Drain: PONDOS WEST DRAIN **Drain #:** 254
Improvement/Arm: PONDOS WEST-SECTION 4
Operator: JOH **Date:** 3-10-04
Drain Classification: Urban/Rural **Year Installed:** 1993

RE: Ponds West Drain-Section 1

RE: Ponds West Drain
Ponds West Sec. 1

Re: Ponds West Sec 1

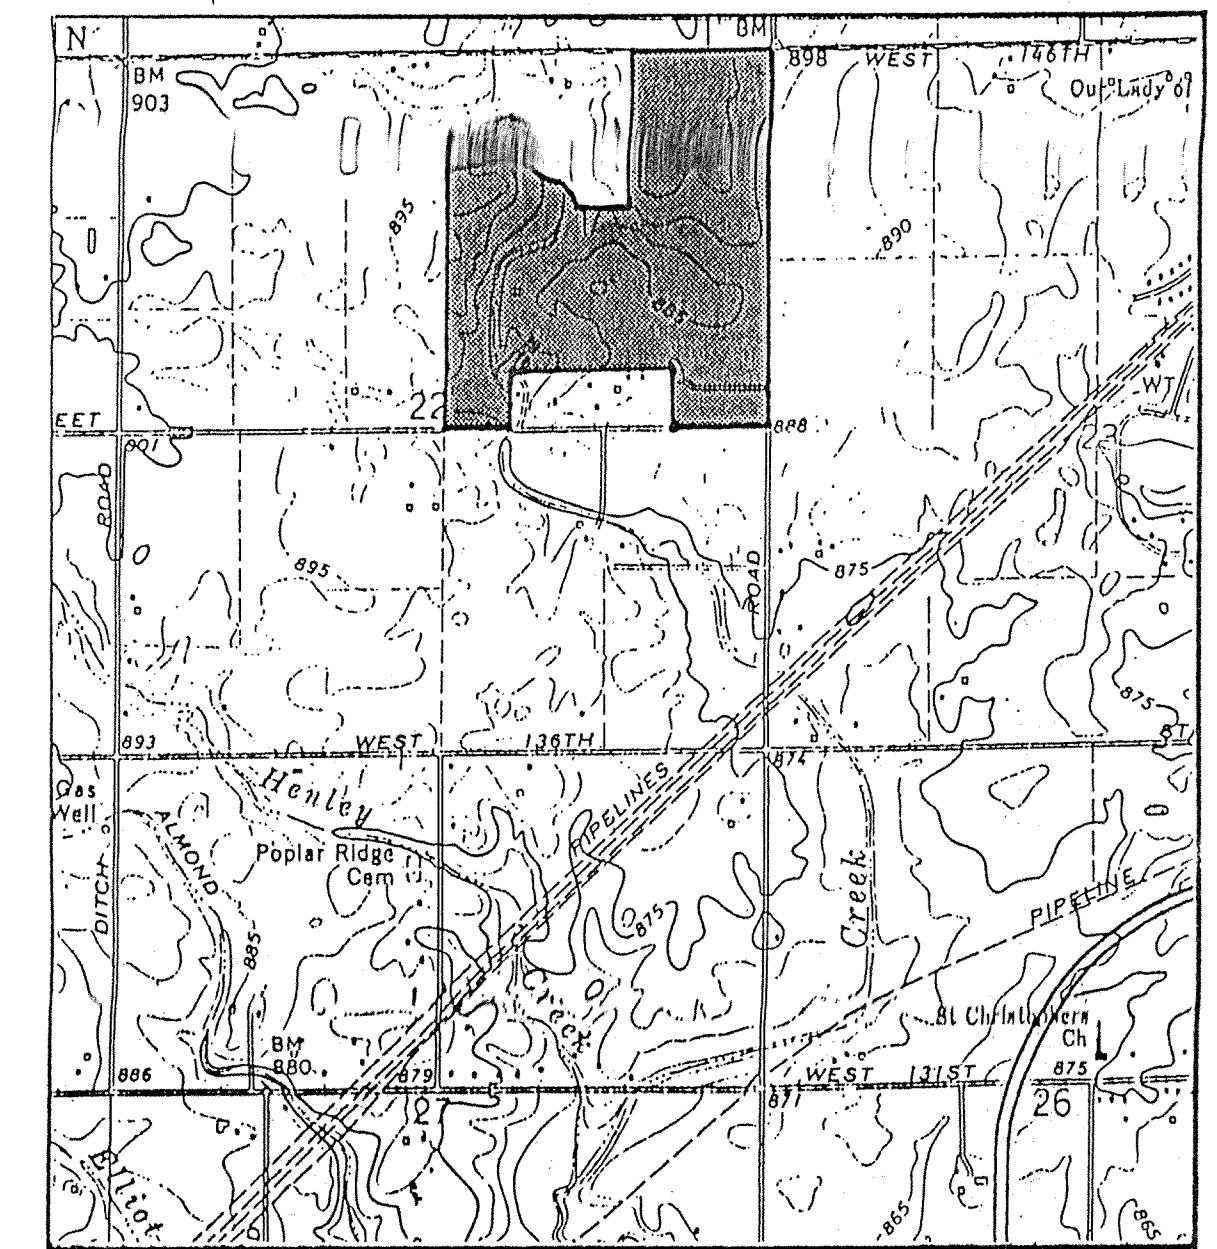
Upon writing the final report for Ponds West Sec 1, a discrepancy was found on the mylar between the drawing and the profile for structures 47 to 48 and 48 to 49. The drawing above the profiles calls for 36" RCP's between these structures. The profile below calls for 30" RCP's. Subsequently, the structures were inspected and were determined to be 36" RCP's. In light of this error, a new mylar needs to be submitted for these structures. The new mylar should note the correct pipe size in the profile as determined by our inspection. Thank you for co-operation in this matter. If there are any questions or concerns please contact us immediately.

Map Correction-Field Verification

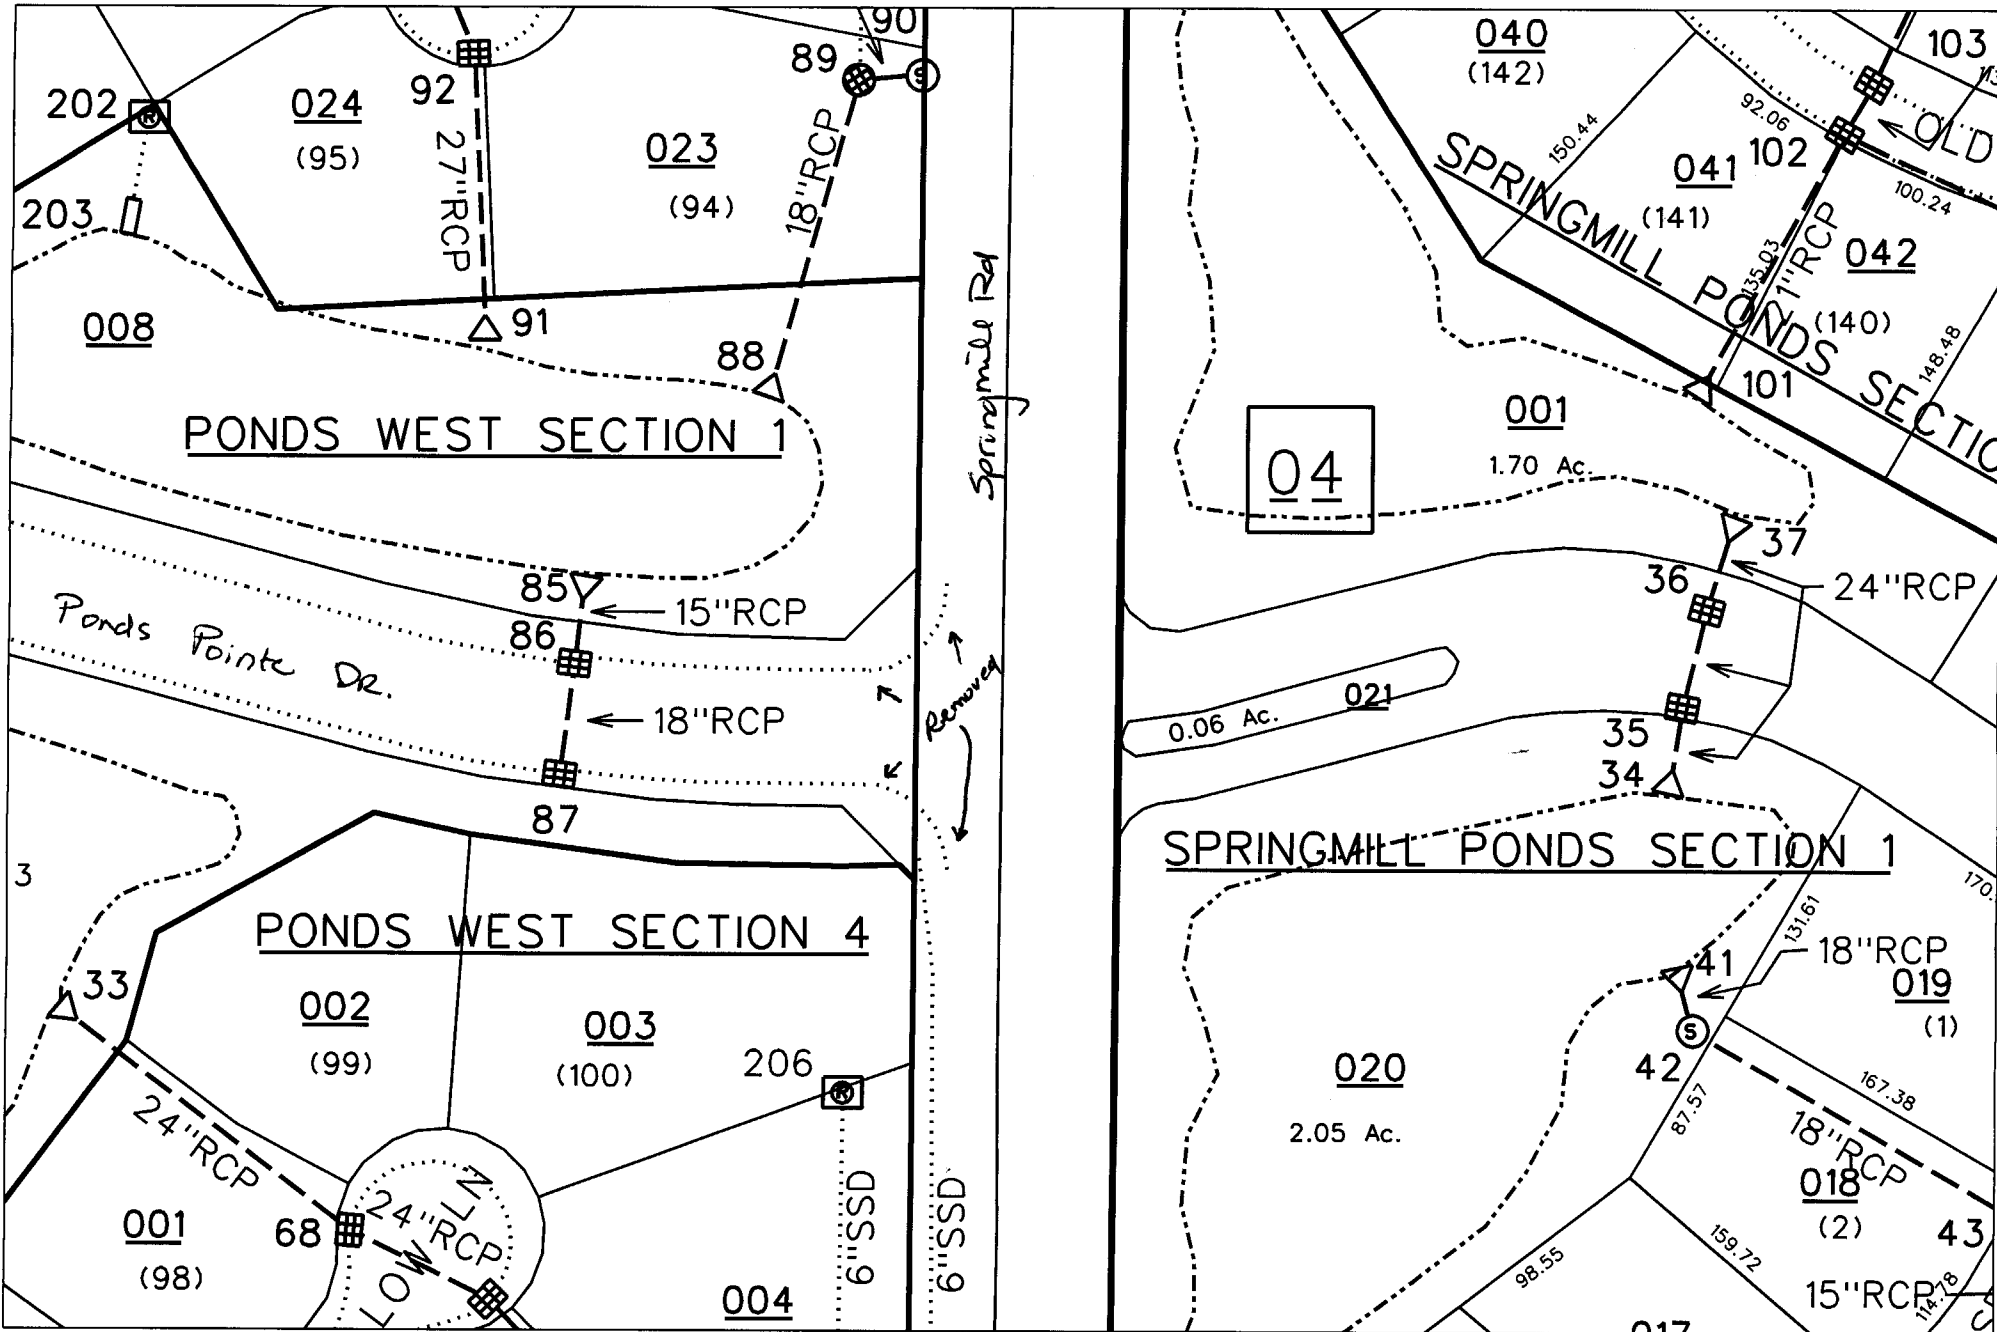
The road improvements made to Springmill Rd in 1997 removed 121 feet of 6" SSD at the entrance of Ponds Pointe Dr.

New Length: 11,588
